**2022 Area Wide Paving
Contract No. BE23-028**

ADDENDUM NO.: ONE

DATE ADDENDUM ISSUED: July 8, 2022

FIRE HYDRANT ACCESS PAD

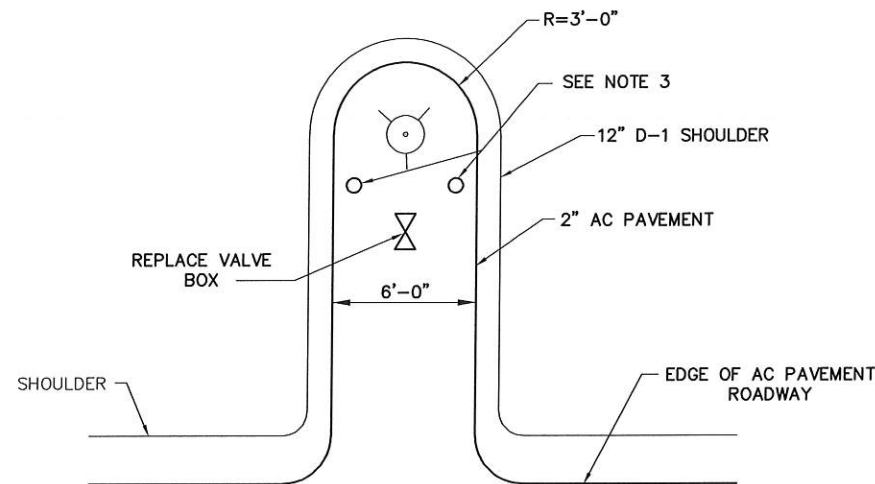
Question: *“There are several hydrants not called out in the bid schedule for hydrant access pads, are these outside the scope of work?”*

Response: See attached Drawing Sheet 3A for Fire Hydrant Notes.

1. CONSTRUCT HYDRANT ACCESS PAD WITH USABLE EXCAVATION AS NECESSARY, 4 INCHES BASE COURSE, GRADING D-1 AND 2" AC PAVEMENT.
2. MAXIMUM ALLOWABLE GRADE IN ANY DIRECTION SHALL BE 2%.
3. REMOVE AND REPLACE BOLLARDS FOR HYDRANT PAD AT THE INTERSECTION OF PATRICIA PLACE AND GLACIER HIGHWAY. THE HYDRANT PAD NEAR THE CUL-DE-SAC ON PATRICIA PLACE DOES NOT REQUIRE BOLLARDS.
4. CULVERTS ARE NOT REQUIRED ON HYDRANT PADS ON PATRICIA PLACE. CONTRACTOR SHALL GRADE SWALES FOR DRAINAGE PURPOSES..
5. CONTRACTORS ARE ENCOURAGED TO VISIT THE PROJECT SITE PRIOR TO BIDDING TO SEE THE EXTENT OF THE WORK FOR THE HYDRANT PADS.
